# Pine Street School Site

Columbia,  
Connecticut

*EASTERN CONNECTICUT  
ENVIRONMENTAL  
REVIEW TEAM  
REPORT*

**Review Date:  
August 30, 1990**

# POSSIBLE SCHOOL LAYOUT

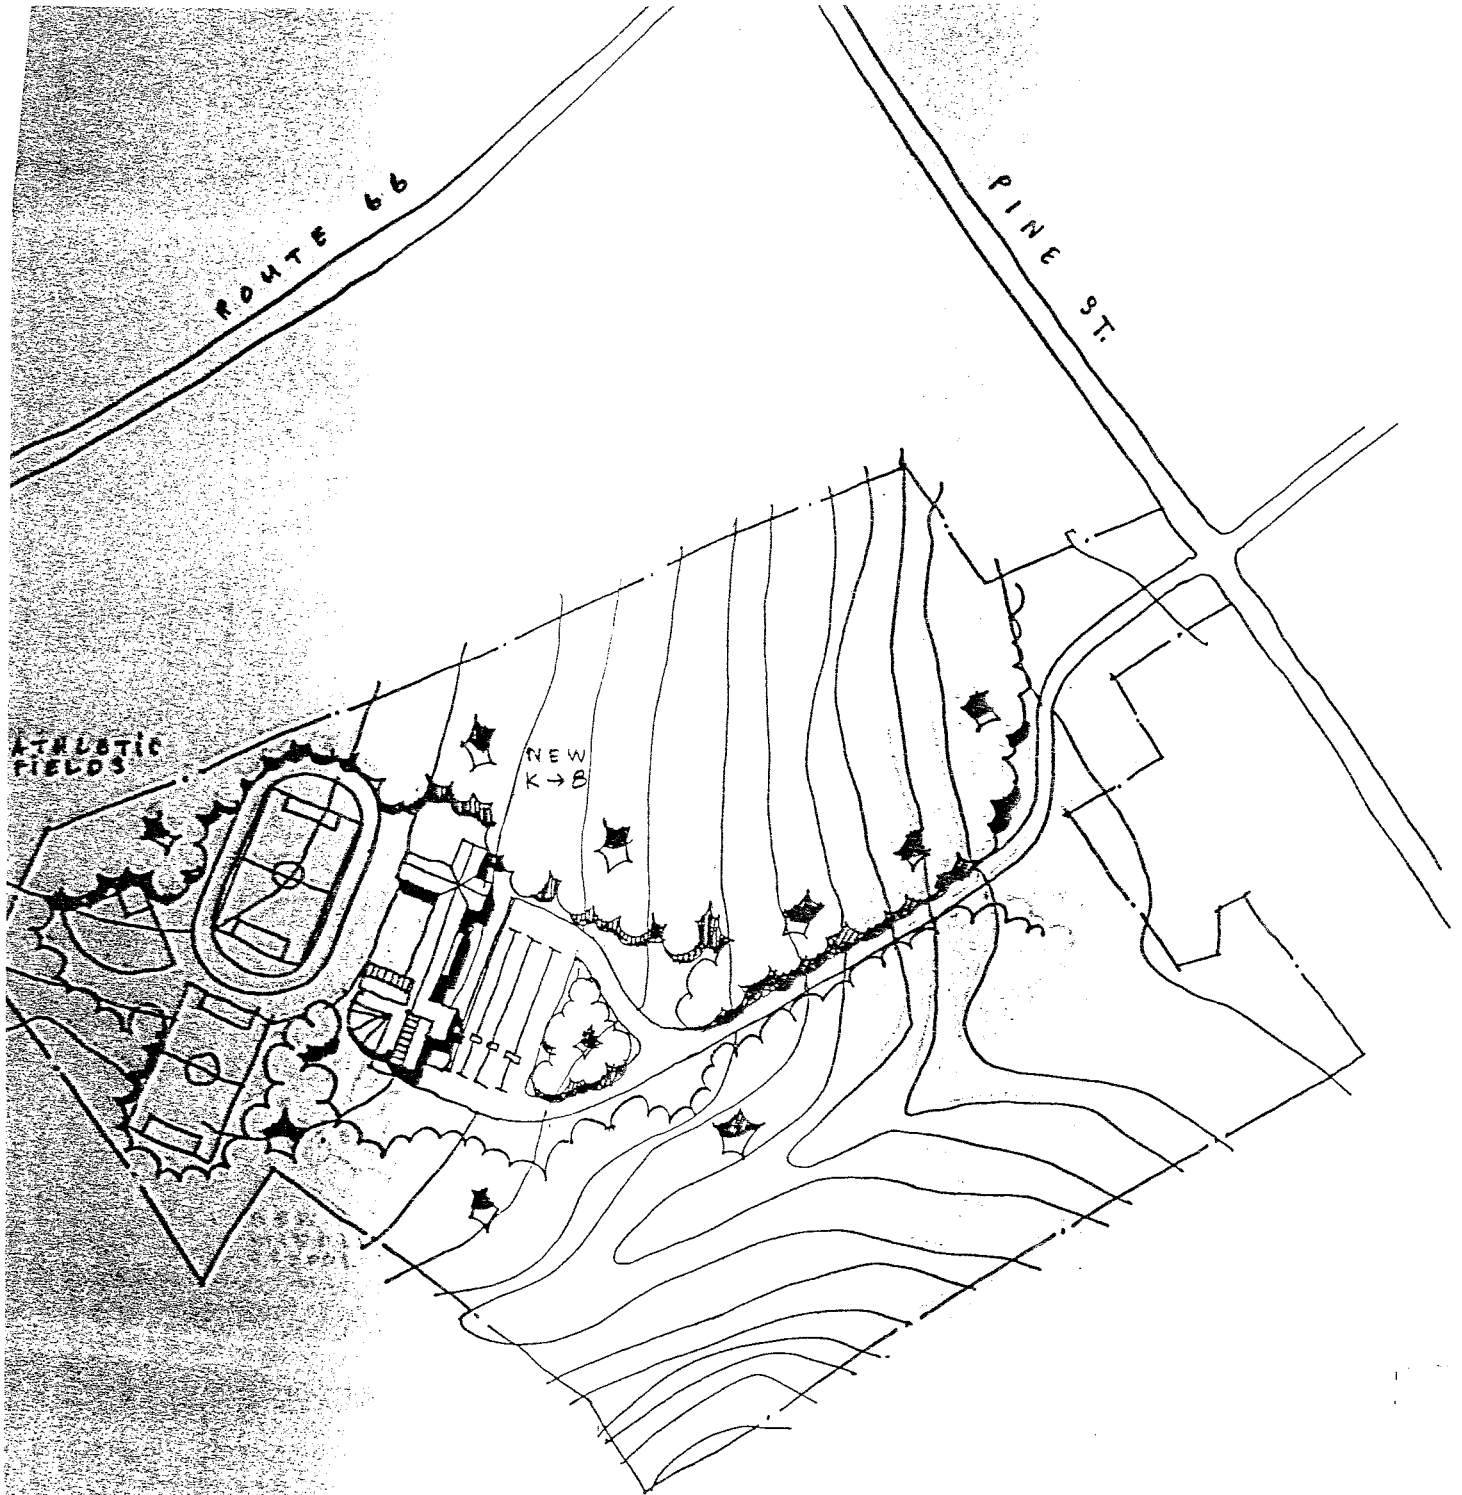
The proposed road network disturbance limits, storm drain outlets, proposed stormwater discharges, and the proposed wetland culvert crossing over Gifford's Brook, need to be addressed specifically. Areas of concern for soil erosion include road cuts and embankments, stormdrain outlets, roadways with proposed grade of 8% or greater and the banks of receiving streams and watercourses. Adequate protection of receiving areas also need to be considered when planning a stormwater management system. Wetland areas and watercourses need to be protected from sediment damage. Sediment laden stormwater and sediment generated during road construction through or across wetland areas are primary concerns. Drainage associated with cuts to facilitate the building and associated athletic fields will need to be addressed, and the proposed drainage outletted in a safe stable area.

The proposed development will have few direct impacts to the wetland and watercourse areas on the site. The access roadway and the school building will be constructed to the north of the main stream corridor. The recreational fields can be situated to the west of the school between the building and the small tributary. As shown on the preliminary plans only one roadway crossing of a watercourse will be necessary. This crossing is proposed to replace an existing farm crossing over an unnamed brook in the eastern portion of the site. The replacement of this already existing structure with one of better design and integrity is not seen as a significant impact to the watercourse.

A second crossing of the watercourse on the southern portion of the property will be made by the septic line to the reserve area of the septic system. This activity will result in a short term disturbance to the watercourse and some sedimentation, but if properly installed should not result in any significant adverse impacts to the system. Other potential impacts which would be expected with the development of this site include sedimentation of the watercourse during construction and long term discharges of stormwater from the site. However, measures can be taken to prevent or minimize impacts from erosion and stormwater runoff. If the project is properly designed and constructed no significant impacts should occur.
